<b>ADDRESSEES</b>	: Owners and operators of coaches listed under 'Application'
<b>VEHICLE MODEL</b>	: T2145 and C2045 with Detroit Diesel DDEC VI engine
<b>VEHICLE SECTION</b>	: Exhaust system
<b>BULLETIN TYPE</b>	: Field Change Program
<b>DATE</b>	: March 30, 2010
<b>SUBJECT</b>	: <b>Exhaust pipe support bracket change</b>
<b>TERMS &amp; CONDITIONS</b>	: Refer to the warranty section further in this Bulletin.

**Figure 3 : T2145 and C2045 with Detroit Diesel DDEC VI engine and Allison B500 transmission – exhaust pipe support bracket assembly, old and new.**

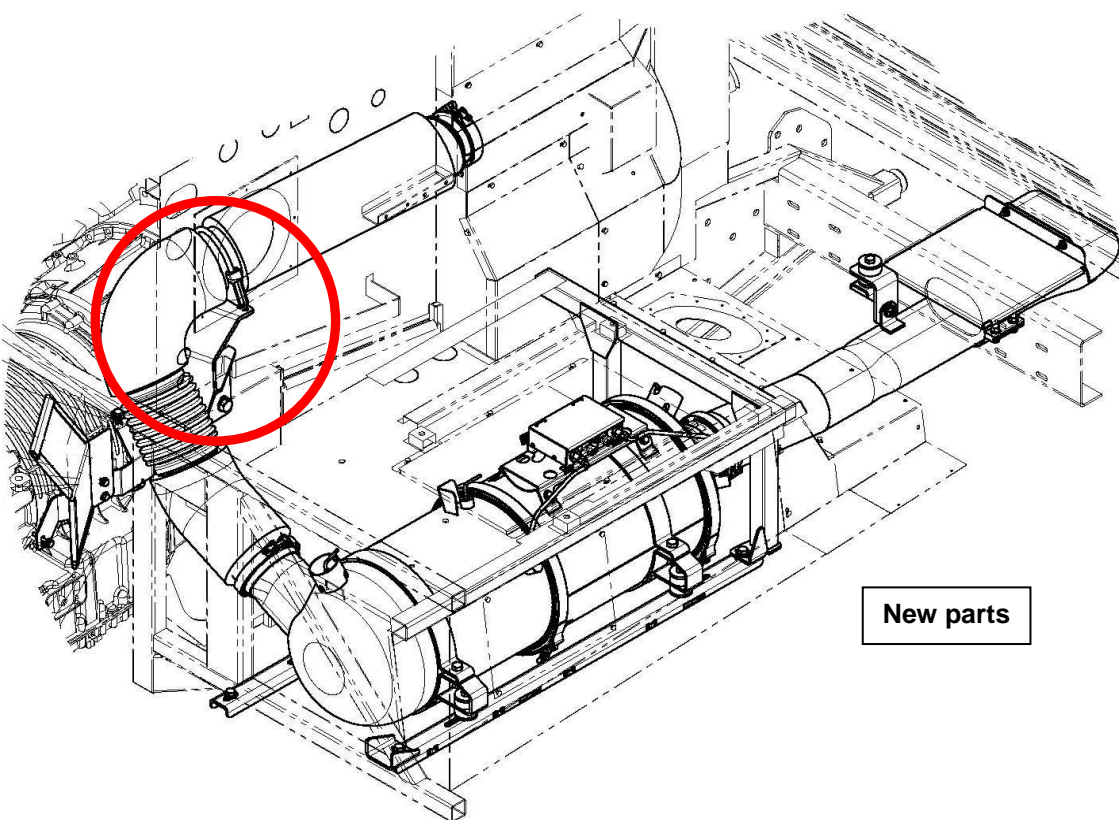
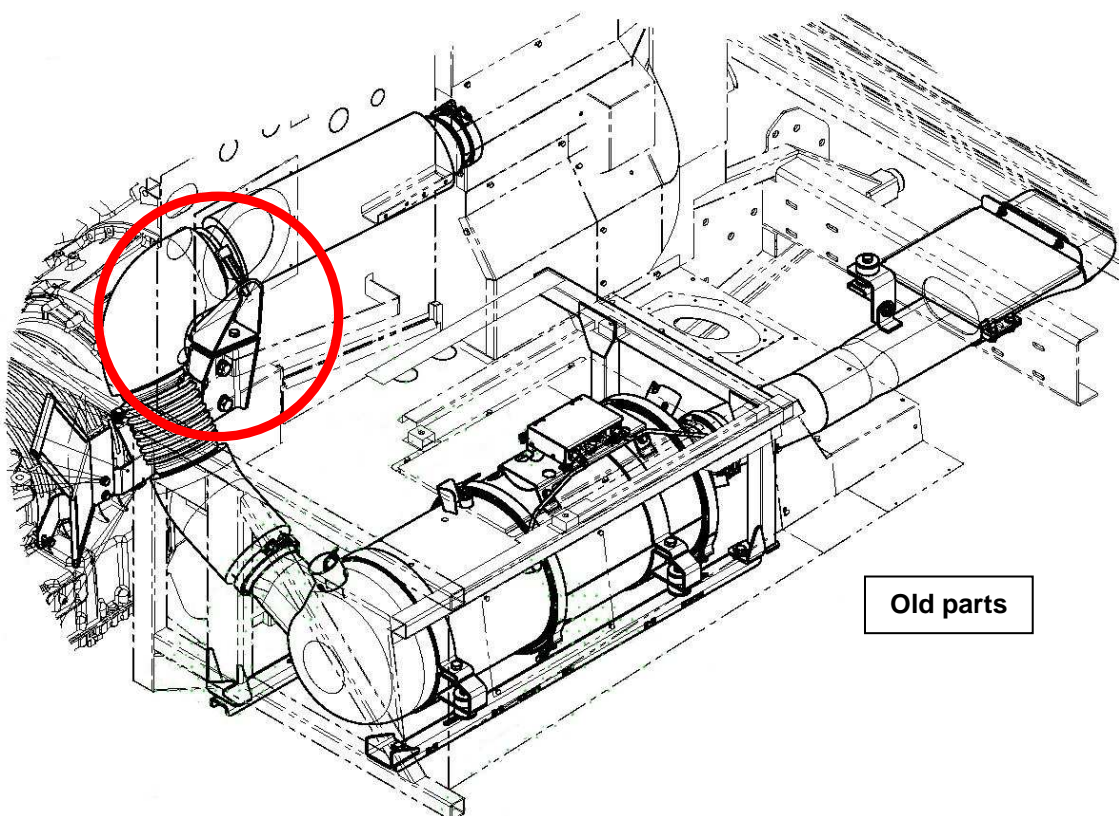
- On the above-mentioned units it is necessary to replace the (transmission mounted) exhaust pipe support bracket assembly (Figures 1 and 2a) by a more flexible design (Figure 2b). The latter is better suited to compensate for the changes in pipe length during the heating-up/cooling-down cycles.

**CAUTION:** Failure to replace the OE fitted rigid bracket assemblies by flexible ones may result in the exhaust pipe cracking at the fuel doser valve.

- In order to avoid damage to the exhaust pipe and restore its useful service life, please replace the OE fitted bracket assemblies on your coach by new, referring to the materials list and the step-by-step instructions further in this Bulletin.

**Old parts (Figure 4, installation on units with Allison transmission shown)**

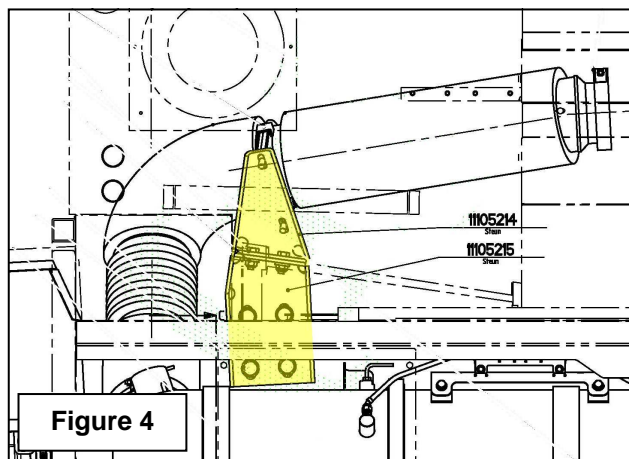
VH reference	Description	Qty.	Application
11105214	Bracket, exhaust pipe support, upper	1	Units w/ Alison B500 transmission
11105215	Bracket, exhaust pipe support, lower	1	
11077918	Bracket, exhaust pipe support	1	Units w/ AS Tronic transmission

**New parts (Figure 5, installation on units with Allison transmission shown)**

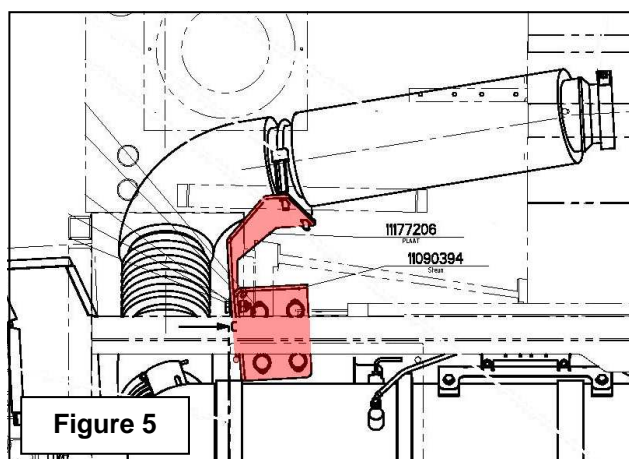
VH reference	Description	Qty.	Application
11177206	Bracket, exhaust pipe support, upper	1	Units w/ Alison B500 transmission
11090394	Bracket, exhaust pipe support, lower	1	
660226601	Bolt, M12 x 1.75 x 35 mm, grade 8.8	2	
660207406	Nut, M12 x 1.75, grade 8.8	2	
660629203	Washer, M12, 13 x 30 x 6 mm	4	
11177914	Bracket, exhaust pipe support	1	Units w/ AS Tronic transmission
